CLIFTON C. LINK JR PROPERTY
 LOT 2

13629 HIGHLAND ROAD
 5TH ELECTION DISTR.
 HOWARD CO., MD
 SCALE = 1" = 30' DATE 6-17-04

TO: HEALTH DEPT. HOWARD COUNTY
ATTN: MIKE DAVIS AND DIRECTOR

REFERENCE LOT #: 2
13629 HIGHLAND RD.
CLARKSVILLE, MD. 21029

SITE PLAN

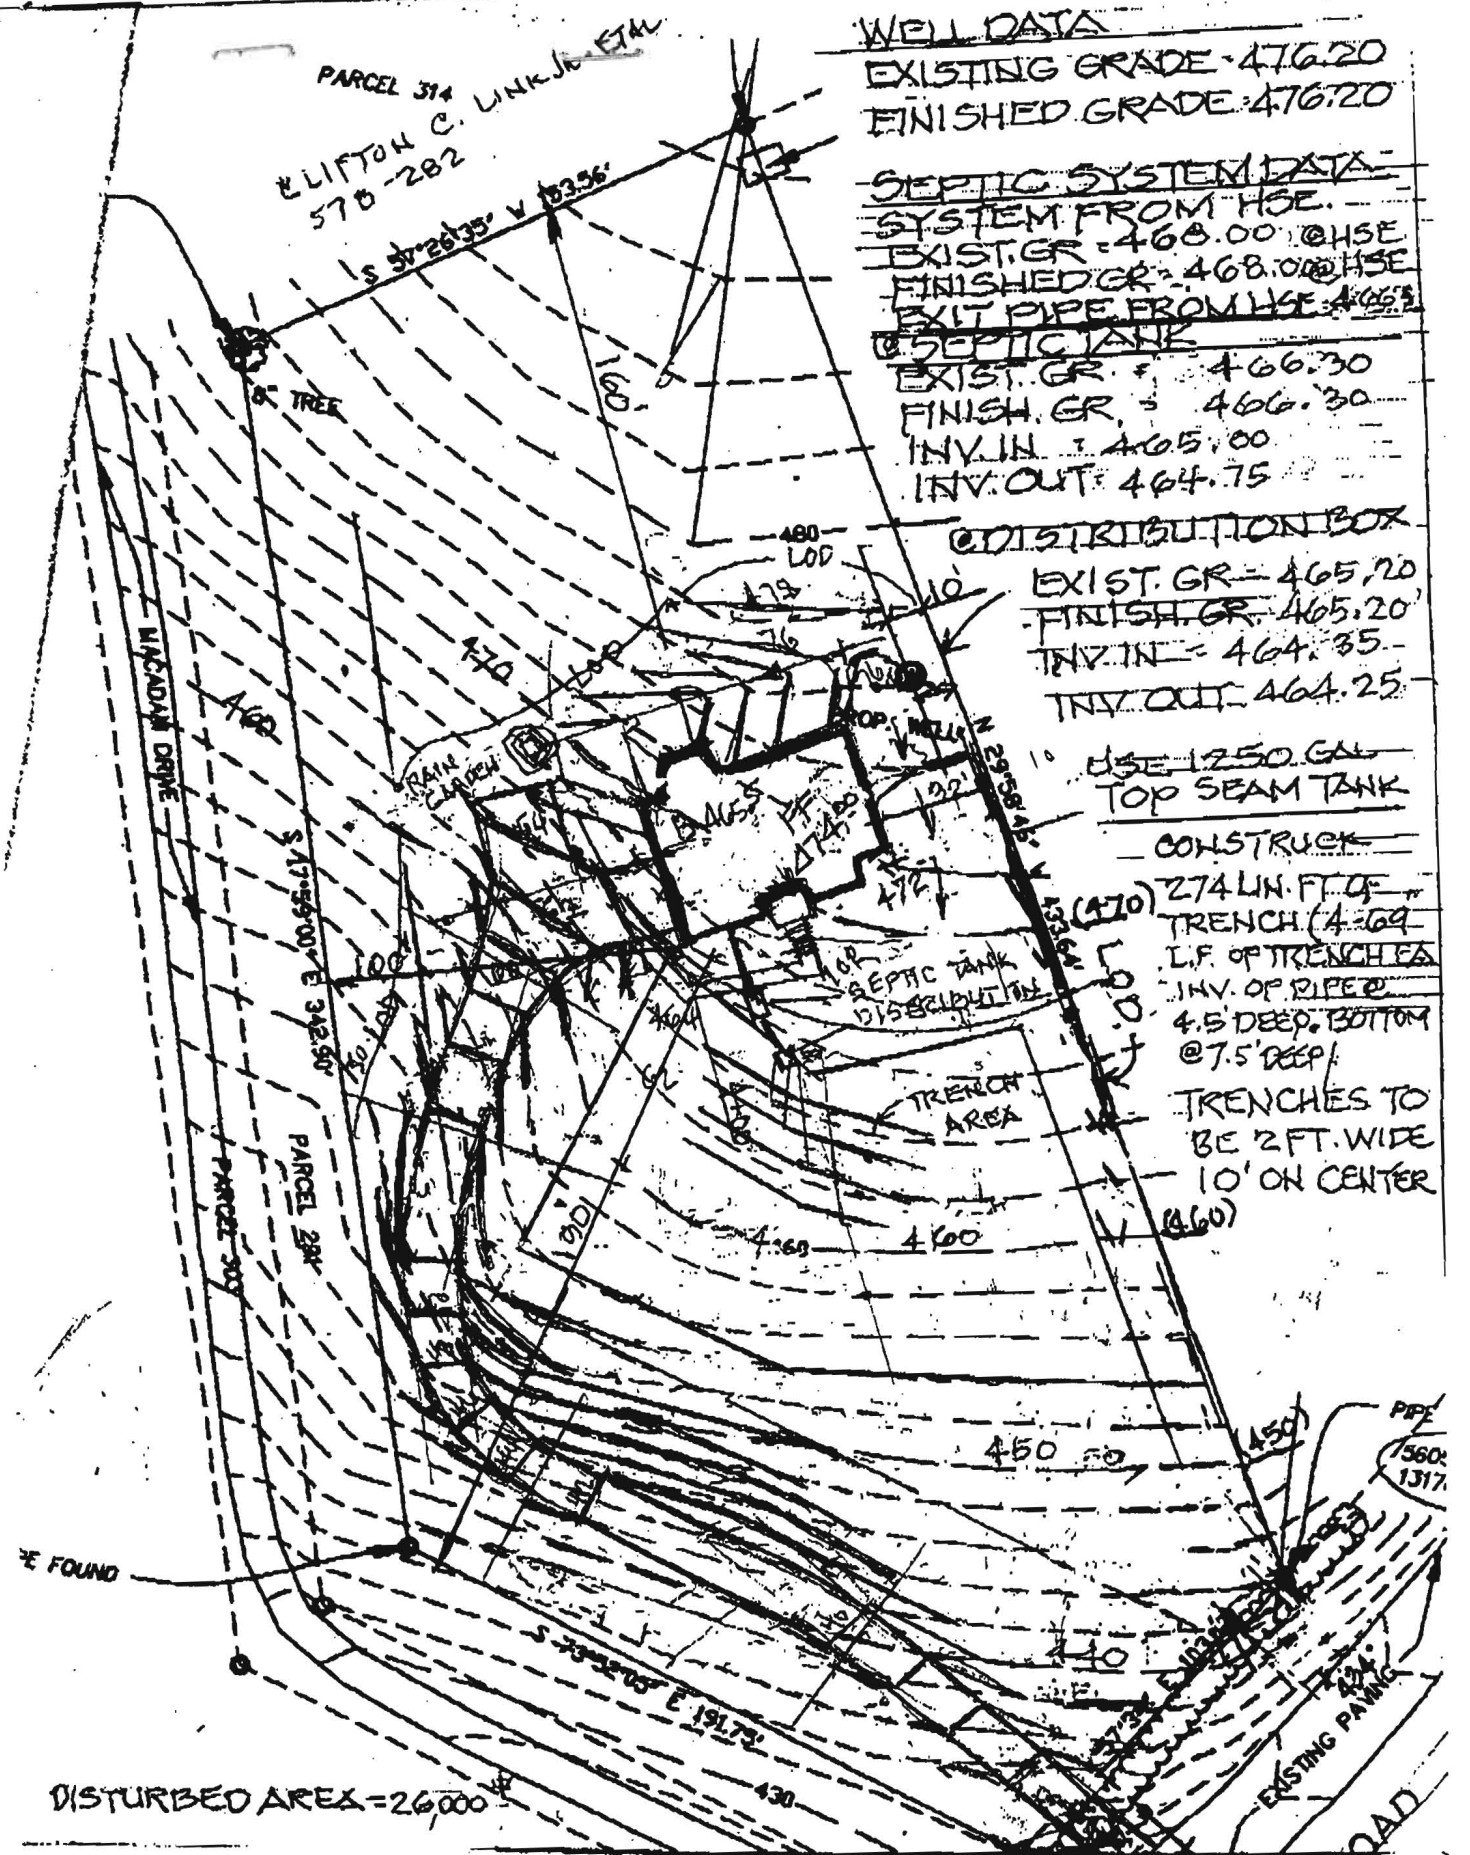
Comments: Plans changed + house flagged

I AM ENCLOSING A REVISED SITE PLAN CHANGING THE LOCATION OF THE HOUSE 10' FURTHER FROM THE RIGHT SIDE PROPERTY LINE. THE REASON FOR THE CHANGE IS THE WELL WAS LESS THAN 30' FROM THE HOUSE. NOW IT IS 32', AND THE ONLY OTHER CHANGES ARE THE SETBACKS.

Mike Davis
approved this
on 12/20/05
(KN)
